Permit Number: 101454

This is to certify that AVESTA OAK STREET LP / VENTURA LIGHT RENTALS CONSTRUCTION
has permission to New 4 story, 37 unit apartment building, 1st story includes secure open private parking garage & limited common
AT 72 OAK ST CE 037 A035001
City of Portland

Project Name: Oak Street Lofts
Project ID: 10-99700002
Project Address: 72 Oak St. **CBL:** 037-A-035-001
Planner: Erick Giles, AICP, LEED AP

City of Portland
Development Review Application
Planning Division Transmittal form

RESILIENT TERMINATION @ TRANSFER SHOWER

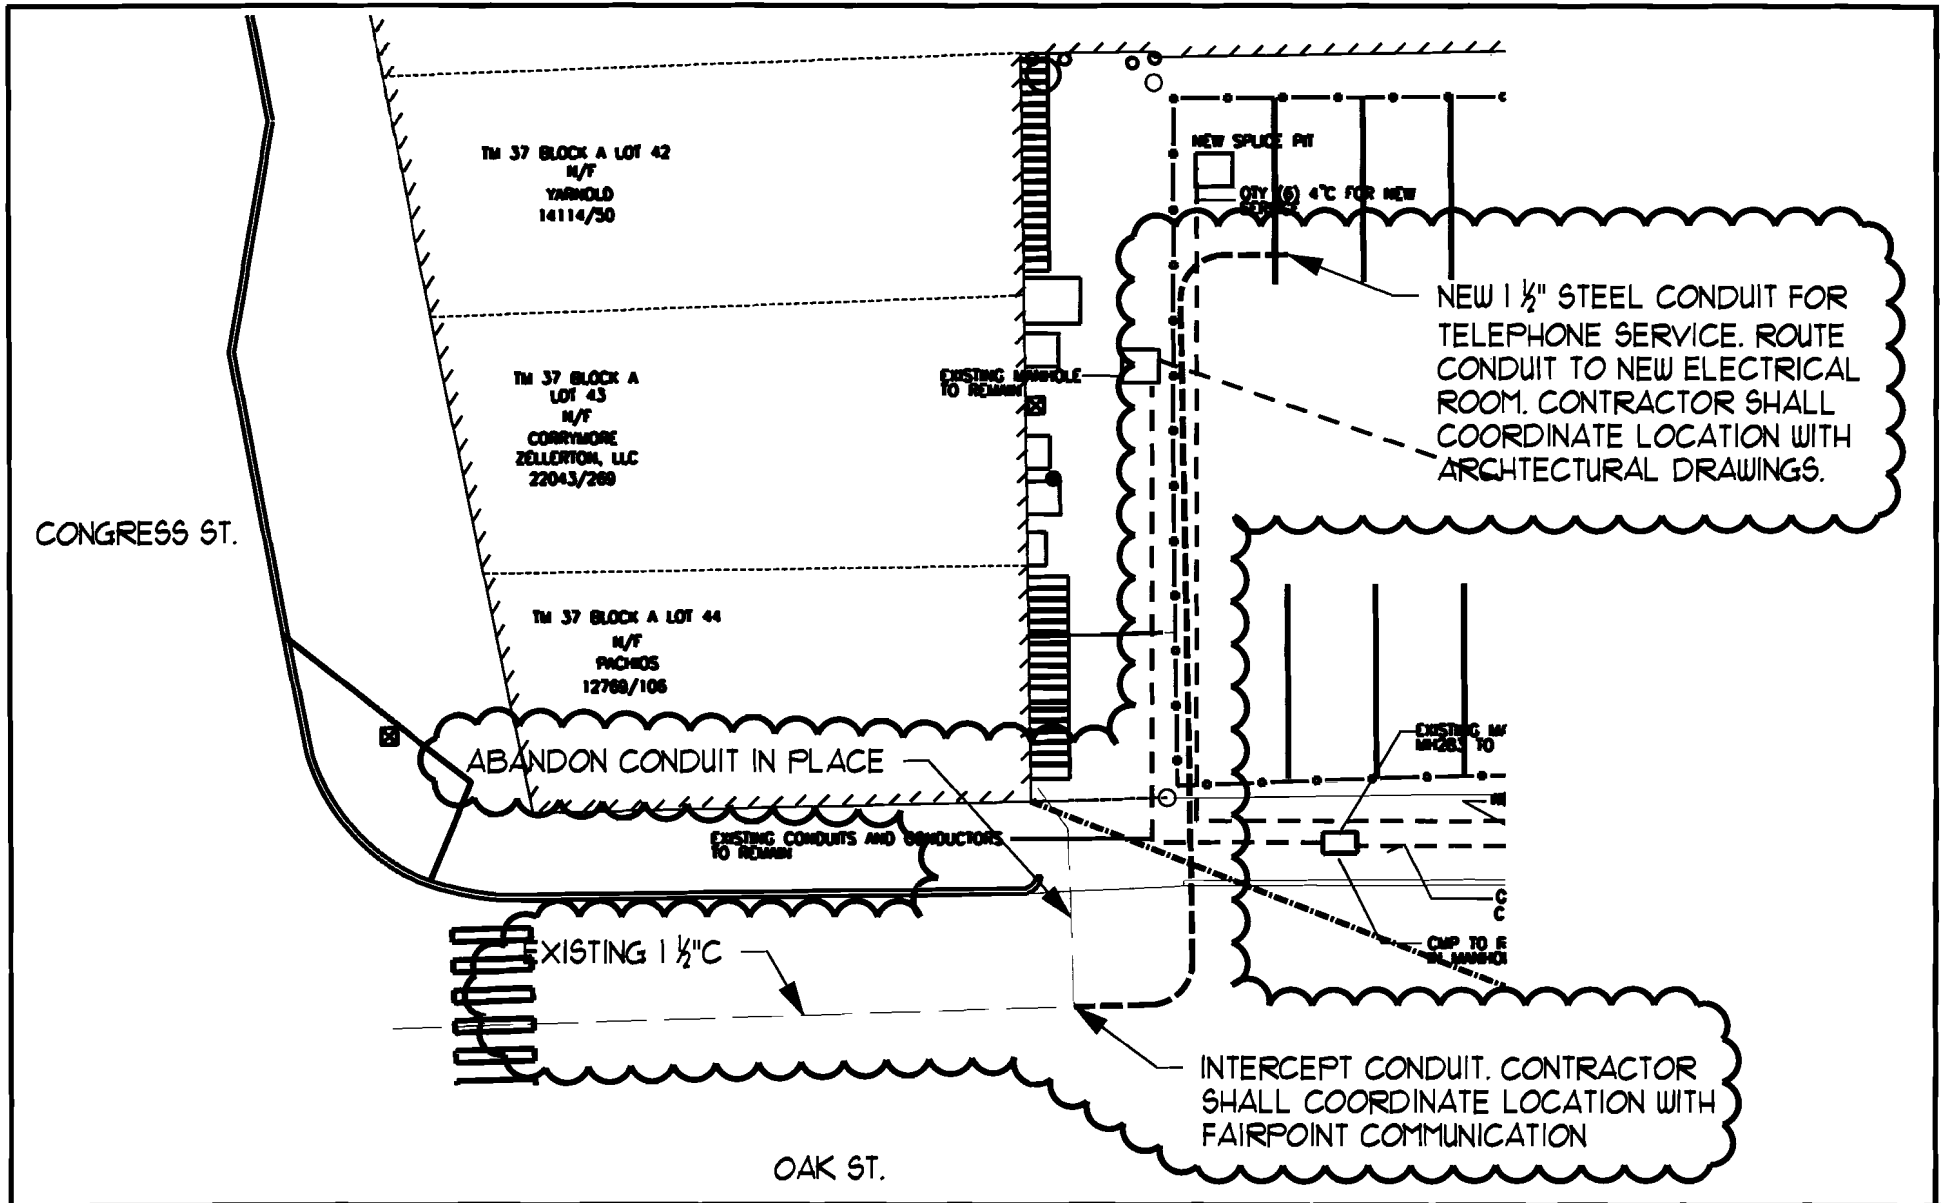
28. On Drawings A 1.8, change all detail reference of flooring transitions at roll in showers to reference Detail 5/A4.13. On Drawings A1.6, A1.7 and A1.9, provide flooring transitions to transfer showers per attached SKA-2 (attached).

C1

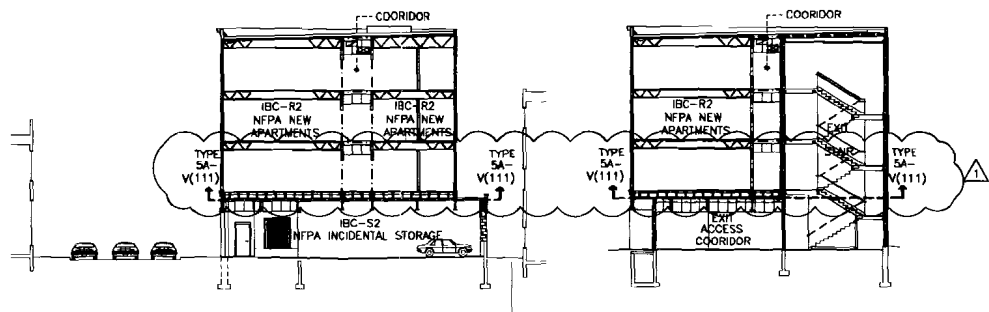
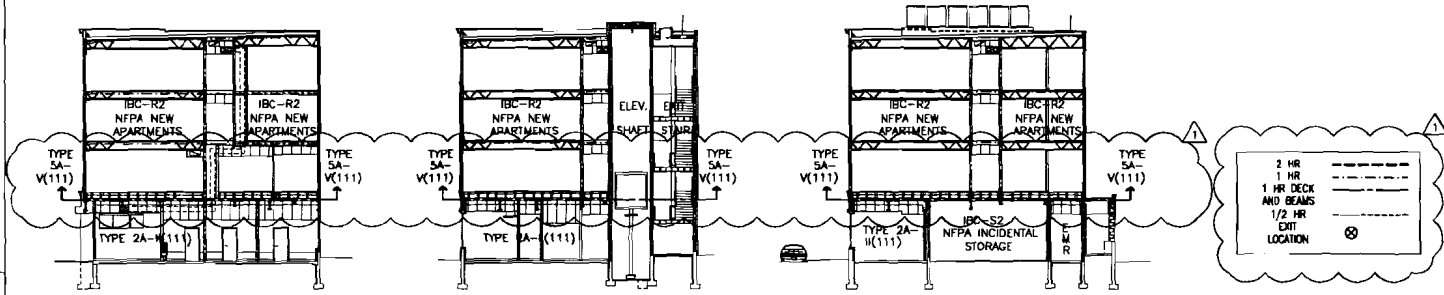
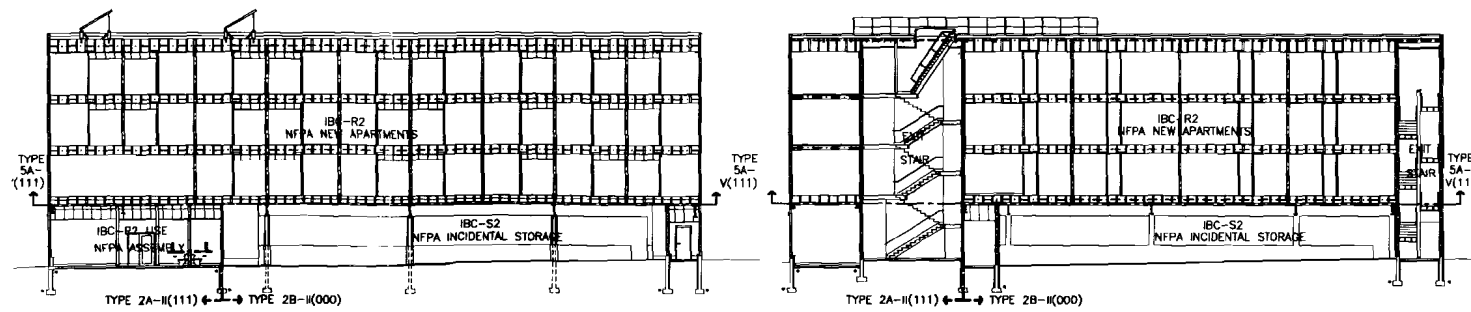
3. Replace Drawing C1 CODE REVIEW PLANS with Drawing C1 CODE REVIEW PLANS Revision 1 dated 3-1-2011. Note that the reprint of this sheet was made at the request of the local Authority Having Jurisdiction and that the actual changes associated with the Drawing replacement were made in Addendum 01.
